Model: NAD 30S/30/40 (3000-sheet Finisher)		Date: 30-Jun-98	No: 7
Subject: Paper rolled-up on the shift tray		Prepared by: M.Mimura	
From: QAC Field Information Dept.			
Classification:	<input checked="" type="checkbox"/> Troubleshooting	<input type="checkbox"/> Part information	<input type="checkbox"/> Action required
	<input type="checkbox"/> Mechanical	<input type="checkbox"/> Electrical	<input type="checkbox"/> Service manual revision
	<input type="checkbox"/> Paper path	<input type="checkbox"/> Transmit/receive	<input type="checkbox"/> Retrofit information
	<input type="checkbox"/> Other ()

Model: NAD 30S/30/40 (3000 Finisher)		Date: 31-Mar-99	No.: 30
Subject: Software Replacement Information		Prepared by: E. Fukuyama	
From: GTSS Field Information Dept.			
Classification:	<input type="checkbox"/> Troubleshooting <input type="checkbox"/> Part information <input type="checkbox"/> Action required <input type="checkbox"/> Mechanical <input type="checkbox"/> Electrical <input type="checkbox"/> Service manual revision <input type="checkbox"/> Paper path <input type="checkbox"/> Transmit/receive <input type="checkbox"/> Retrofit information <input checked="" type="checkbox"/> Other

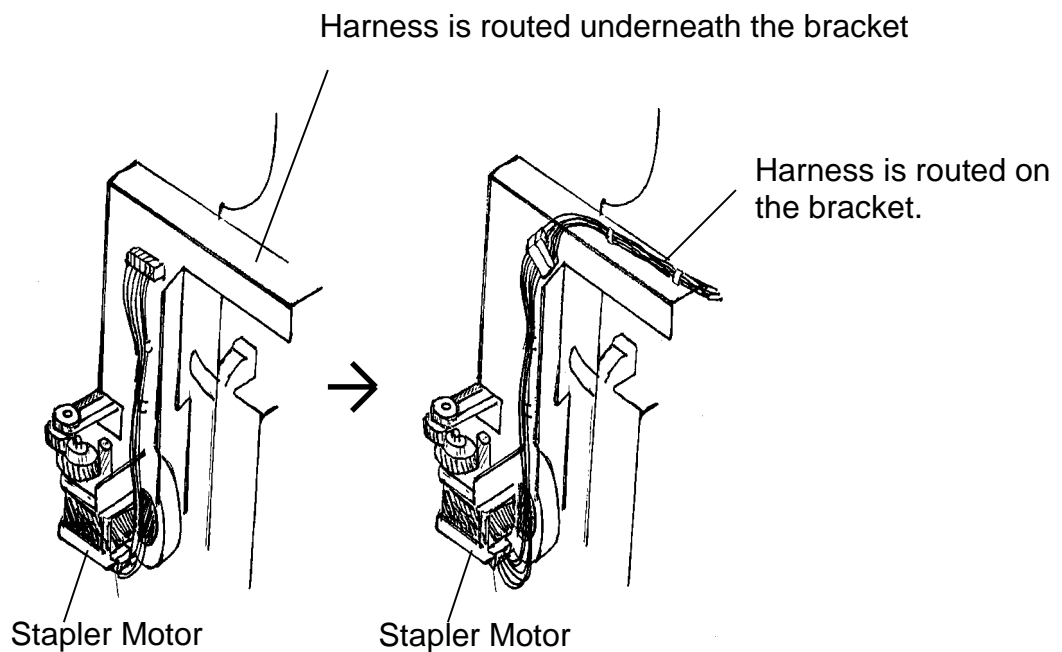
To prevent the stapler motor harness from being damaged, the harness route has been changed as shown in the illustration below:

Cut-in serial number for the harness route change:

- A697 - 15 : 1B59030221~
- 17 : A7779030001~
- 22 : AR39030001~
- 26 : 3R10390001~
- 55 : L0329032032~

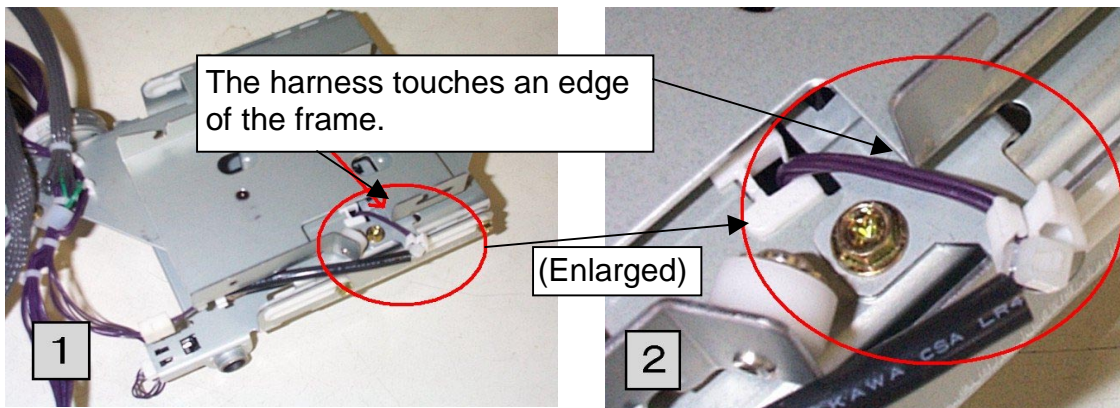
The stapler rotation HP sensor harness shorts to the frame

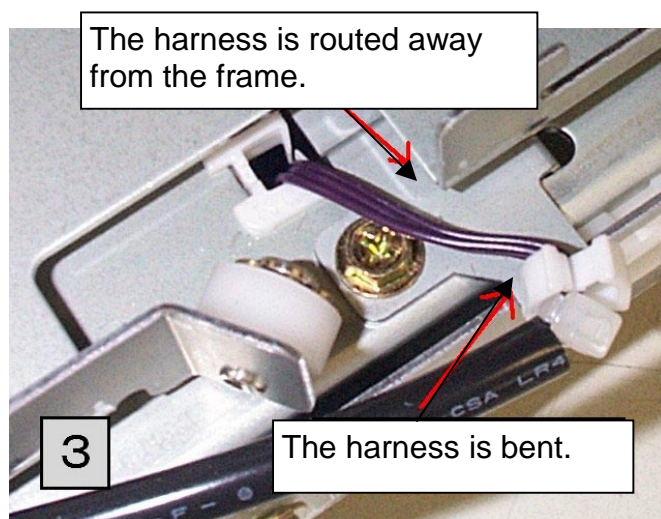
The routing of the harness has been changed as shown in the photo. This can be done in the field.

A tape wrapping the harness has been added to the place where the harness touches the frame and the frame has been changed to make the edge smoother.
